# SUBJECT: Safety Recall 15S39 2003-2005 Model Year Crown Victoria and Grand Marquis Vehicles Headlights Inoperative

# Safety Recall 15S39

# **FIGURE 1**

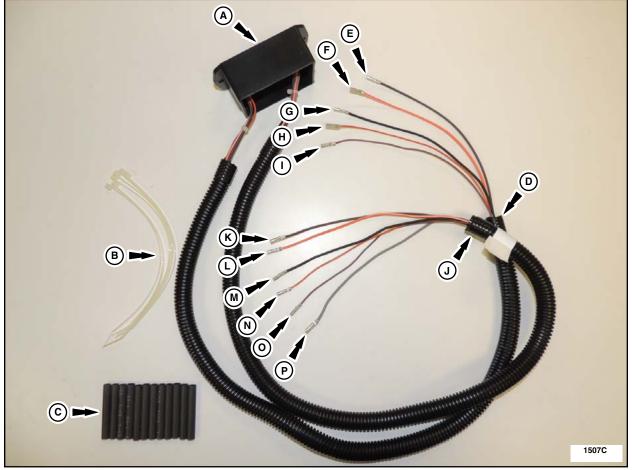
**NOTE**: The 5-wire side of the LCM bypass module must be connected to the LCM (component) side of the harness.

The 6-wire side of the LCM bypass module must be connected to the vehicle side of the harness. The 6-wire side of the LCM bypass module harness has a part identification label attached near the end of the convolute.

**FIGURE 2**

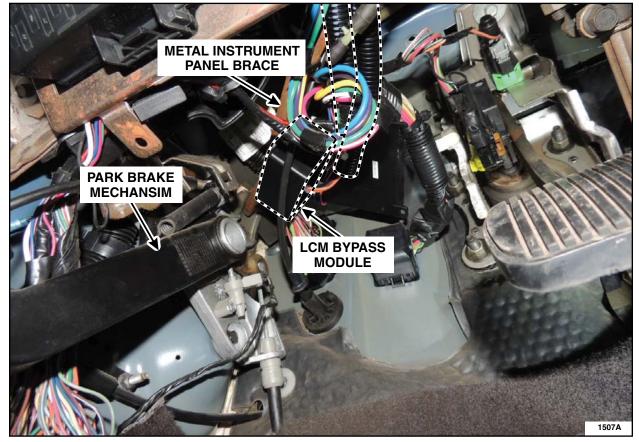
- **NOTE**: Do not install the instrument panel lower insulator until after the LCM bypass module and harness have been mounted and secured.
- 6. Mount the LCM bypass module to the metal instrument panel brace located under the driver side instrument panel, above the park brake mechanism. Figure 2.

FIGURE 3

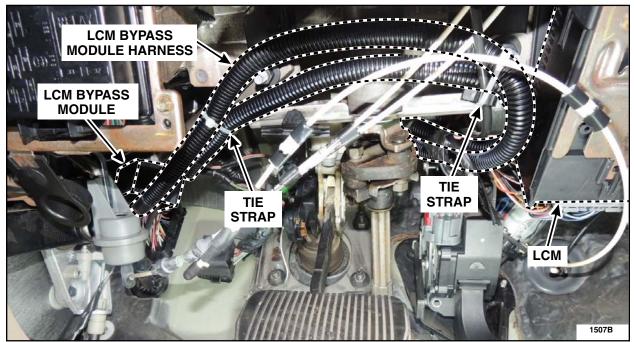
- 7. Route and secure the LCM bypass module harness as shown in Figure 3, using tie straps as necessary.
- **NOTICE:** Verify the LCM bypass module harness is secured away from all sharp edges and moving parts.
